11.6 Roseburn Park Walk and Cycle Improvements

Consultation Summary Report

March 2017

Figure 1 Roseburn Park proposals

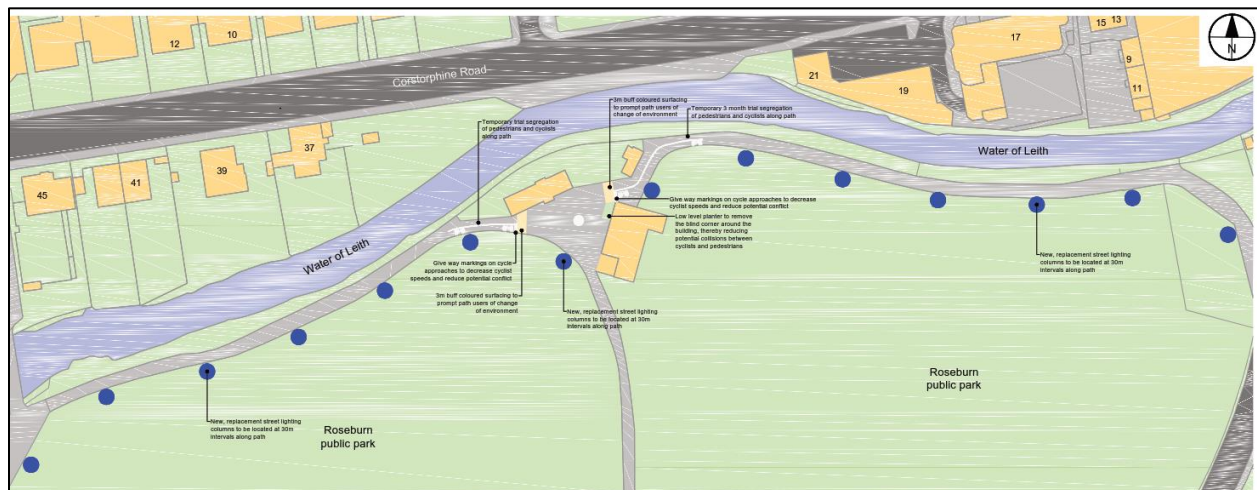
24	Support		
38	Support		
39	Support	There is a blind spot at the former toilet block which should also be addressed. Please don't lay tramline tactile paving as it is slippery and unsettling to cycle over. To be of most practical value, the route needs to seamlessly tie into the Roseburn - Leith Walk East West Route and also into the NCN1 from Roseburn. Whilst welcoming this quiet route leisure cycling project, the East - West Route should also continue west along the main road to Corstorphine. Only then will there be significant modal shift by commuters.	The scheme proposes to address this blind spot by directing cyclists to the other side of the path. We shall evaluate how effective this has been after the 3 month trial.
49	Support	Many studies have shown that signage doesn't slow vehicles down, the actual physical environment needs to enforce the behaviours you are seeking to encourage. The planter is a good idea, as it physically changes the blind corner. However, I'm not sure how effective the painted pavement is going to work. I'd also suggest widening the path before splitting it, as I'm not convinced it is wide enough for such segregation.	At 5m wide, the path is considered by the Council to be wide enough for segregation. Elsewhere in Edinburgh, where paths have been segregated with white lines, this has been shown to improve interaction between path users. This is a 3 month trial and we shall evaluate its effectiveness before proposing a permanent solution.

36	Support		
33	Support		
59	Neither support or oppose	The idea of delineating separate space for bikes and those walking is good in principal, but I doubt the proposed design will make much difference with such short lengths of paint. I am also unconvinced of the benefit of installing the tactile paving in this location, as there is no real segregation to remark, and it can feel unsafe to cycle across when wet. I like the idea of the low level planters to reduce conflict at the building corner, but unsure what the white spot in the middle of the junction represents? If it is the intention to turn this into a roundabout, I think that is unsuitable for a shared use path in a park	This is a 3 month trial and we shall evaluate its effectiveness before proposing a permanent solution. The buff surface will take to form of an anti-skid surfacing whether than tactile paving. As such it will less slippery than the rest of the path, even when wet. The white spot represents the existing raised flower bed, which shall be retained.

9	Neither support or oppose		
42	Neither support or oppose	I would like to know the width of space allocated to cyclists and pedestrians.	Along the segregated section the path is roughly 5.5m meters wide. Half of this width shall be given to people on foot and half to people on bikes.
17	Neither support or oppose	The proposed design is simply the status quo. It is the route I currently use and it involves narrow roads with traffic, parked cars, speed bumps and dangerous junctions.	The alterations are a change from the current situation which are designed to address the issues of conflicts and safety for all path users.
47	Neither support or oppose		
40	Neither support or oppose	Not clear why the lamp posts are being replaced.	Many people have highlighted that the current lighting is insufficient and makes some users feel unsafe when using the park at night.
5	Oppose	The painting of lines to separate walkers and cyclists is not ideal. There should be a design led approach to creating a safe cycling and pedestrian environment in areas where there is a need for slow movement. Better approaches are out there!	This is a 3 month trial and we shall evaluate its effectiveness before proposing a permanent solution. However, the support indicated from this consultation suggests the proposal is appropriate.

7	Oppose	While I strongly support improvements, I do not think the detail shown on sheet number 60512201-SKE-C-WP2-11.6-0102 and in the supporting information is an appropriate response. The supporting information states that "Separating sections of the main paths so that people walking use one side and people cycling use the other". My experience of using paths where this type of separation is included is that, in practice, people do not neatly organize themselves into the sections that they are intended to use. I have concerns regarding this as marking out sections in this way also promotes a sense of ownership and priority, which often translates as inappropriate speed. In short, while this approach is recommended in Cycling by Design, my experience is that the proposed separation is designing in conflict as the theory is sound but behaviour does not necessarily align with it. I welcome the intention to trial this approach for 3 months but have concerns that it may become a permanent feature without review. The use of different surfacing materials to reinforce change of environment, particularly at the junctions, is sensible although care should be taken with alignment of tactiles as sheet number 60512201-SKE-C-WP2-11.6-0102 does suggest that these may be positioned at points where cyclists are changing direction, increasing the likelihood of falls, particularly in less experienced riders. Careful consideration to alignment will be required when these are installed. On a more general point regarding surfacing, the path surface through the park requires attention in places and I hope that this is within the scope of the improvement works.	This is a 3 month trial and we shall evaluate its effectiveness before proposing a permanent solution. However, the support indicated from this consultation suggests the proposal is appropriate. Where paths are segregated, such as in the Meadows, we tend to find that interactions between path users is improved. The buff surface will take to form of an anti-skid surfacing whether than tactile paving. As such it will less slippery than the rest of the path, even when wet.
